Bridging Design Excellence Strategy

Shop top housing with in-fill affordable
housing SSDA

691-699 Pacific Highway, Chatswood

Prepared for
DPG Project 38 PTY LTD
March 2025

FIGURE 16 – INCREASED FLOOR TO FLOOR HEIGHTS – PREFERRED OPTION 3200MM FTF

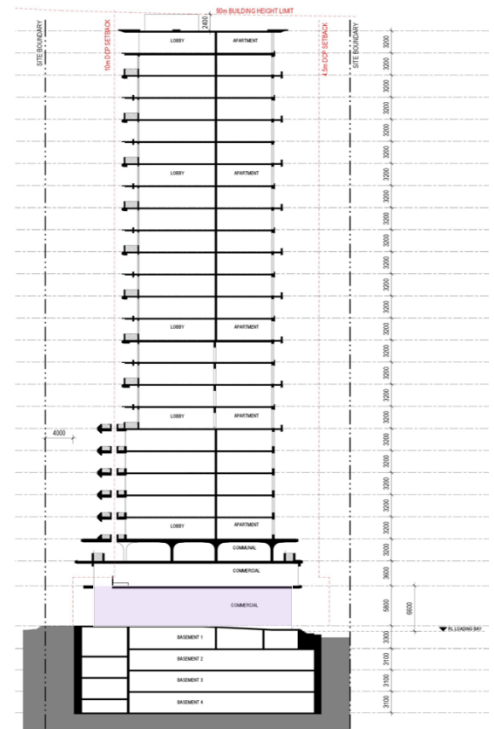
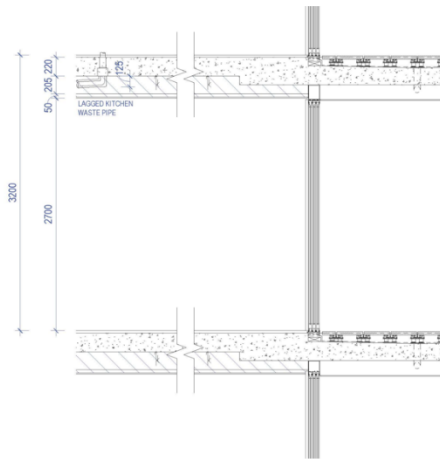
- *Adopt an increased floor to floor height allowance for residential levels (3200mm minimum)*
- *Consider what the resulting outcomes could be to comply with the height controls by:*
- *Rethinking the inclusion of the penthouse rooftop terraces*
- *Redistributing GFA to the Podium Rooftop level to provide internal communal facilities for residents in addition to outdoor communal open space.*

In response to Jury comments regarding increasing floor to floor heights, Squillace clarified the following:

- Both 3150mm & 3200mm floor-to-floor options were explored for residential levels.
 - Both required a reduction of one storey to comply with the LEP height limit due to the 5400mm lift overrun. Therefore, the 3200mm floor-to-floor option was preferred.
 - The Ground Floor was also increased to 5800mm floor-to-floor.
- A roof terrace is still possible due to the height of the lift overrun from the roof's FFL.
- The additional GFA from the exclusion of one storey was relocated to:
 - Top of podium communal area facing Pacific Highway.
 - Enlarged living areas to the 3-bed units and some 2-bed units.

FIGURE 17 – PODIUM PLANNING – REVISED GROUND FLOOR PLAN

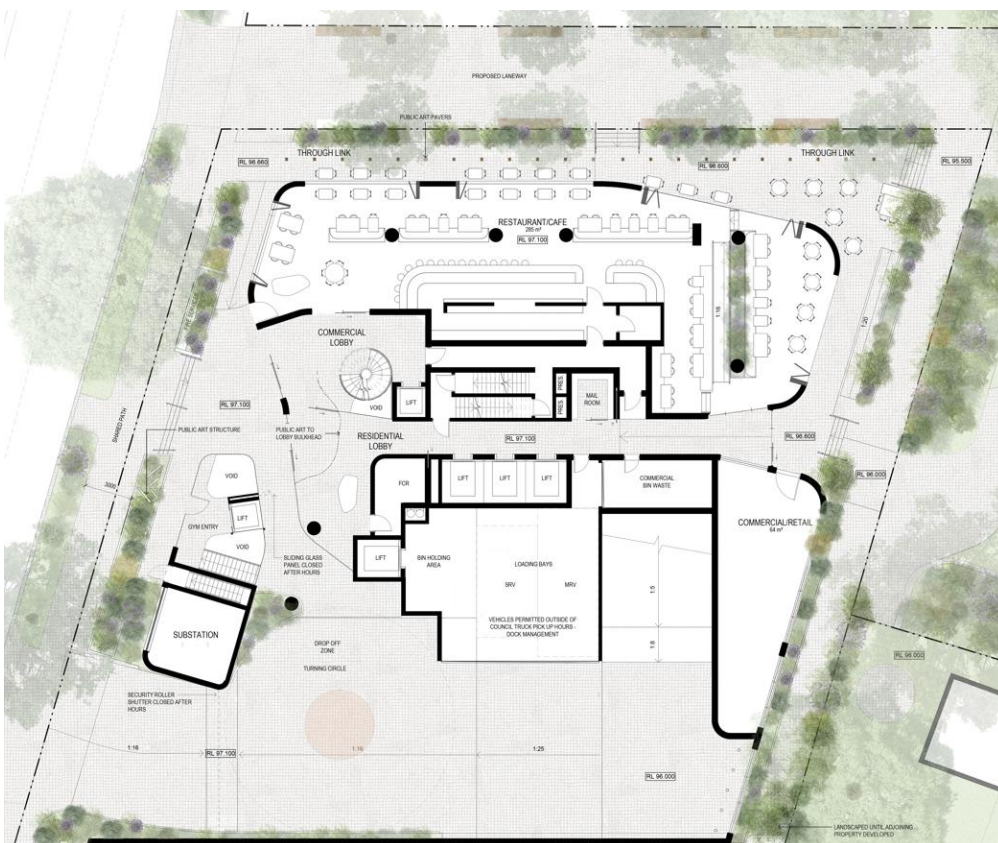
- *The extent of fragmentation in the ground floor plan and the depth of entries in relation to CPTED principles*
- *The introduction of natural light and view lines into the basement gym by:*
- *Introducing a void or expanded stairwell in the commercial lobby to the basement*
- *Reconsidering the provision of the small retail tenancy to the Pacific Highway (could it be a void to the basement gym instead?)*
- *A combination of these strategies or the consolidation of these areas.*
- *The inclusion of arched portal openings to the podium facade competes with the undulating facade line in plan. Could the geometry of the openings be simplified to compliment the orthogonal brick components of the tower facade without impacting the overall character of the podium? Could this assist in simplifying the overall expression of the proposal (see notes below)?*

In response to Jury comments regarding podium planning and facade expression, Squillace included the following design responses:

- With further consideration to CPTED principles, the following items were adopted within the ground floor (**Figure 17**):
 - An after-hours roller door to the driveway entry/drop-off zone.
 - An after-hours slider to the pedestrian entry of the drop-off zone.
 - The eastern entry pushed east to reduce the depth of the entry.
- To introduce more natural light into the basement gym:
 - Relocated gym entry to the small retail tenancy on Pacific Highway.
 - Introduce voids in small retail tenancy and the commercial lobby.
- To future-proof for 12.5m HRV, this was accommodated by:
 - Shifting the core north
 - Straightening ramp to the basement
 - Reducing size of the southeastern retail tenancy.
- Simplifying the geometry of the podium façade opens to be more orthogonal, which references the lower tower's form (**Figure 18**).

FIGURE 19 – FAÇADE EXPRESSION – REVISED TOWER FORM

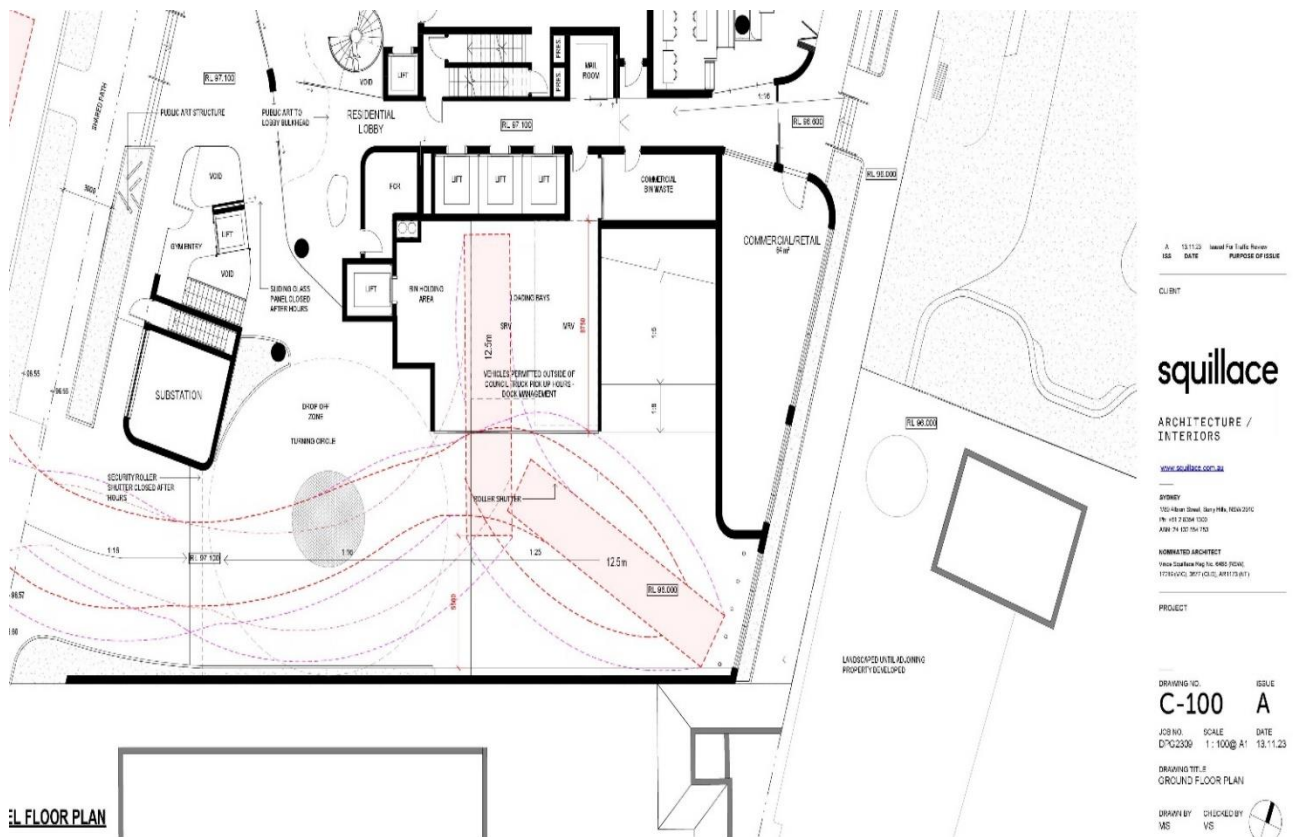
- *Consider reducing the number of predominant tower facade materials in relation to previous commentary.*
- *The proportions, plan geometry and expression of the eastern residential facade does not achieve the same level of slenderness or clarity as the western facade. Reconsider this facade by:*

- The eastern façade amended to include:
 - Vertical break similar in proportion to the western façade.
 - Vertical grids to reference the western façade while maintaining larger openings to not restrict views and direct sunlight.

- A continued lower tower expression of the texture GRC or Brick GRC.

FIGURE 21 – REVISED FLOOR PLAN LAYOUT – LEVELS 8-16

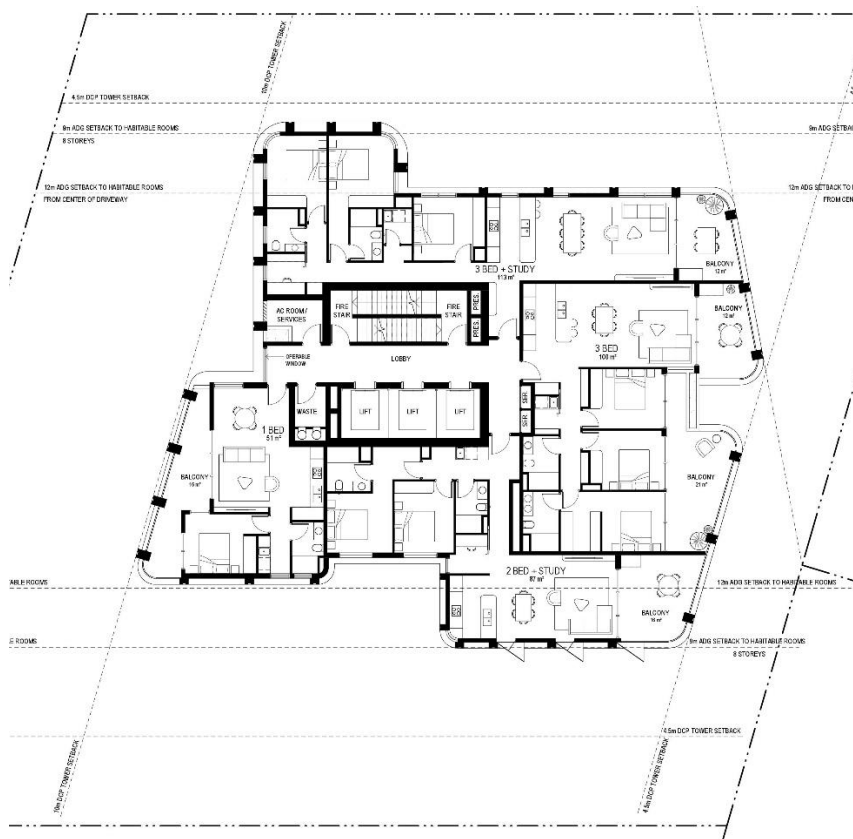
The Jury broadly supports the planning of the tower floor plates and the resulting quality and amenity of the proposed apartments. The Jury has however identified a number of issues for further consideration and would like the design team to address these by focusing on a single typical level 8-11 rather than replanning all tower levels. The issues to be reconsidered are:

In response to Jury comments regarding tower and apartment planning, Squillace provided the following design responses (Figure 18, Figure 21 and Figure 22):

- Floor plan amendments including:
 - Reconfiguration of the mid-rise tower floor plan by continuing the slender proportions of the upper tower down, eliminating the wings and providing the client flexibility with unit mix.
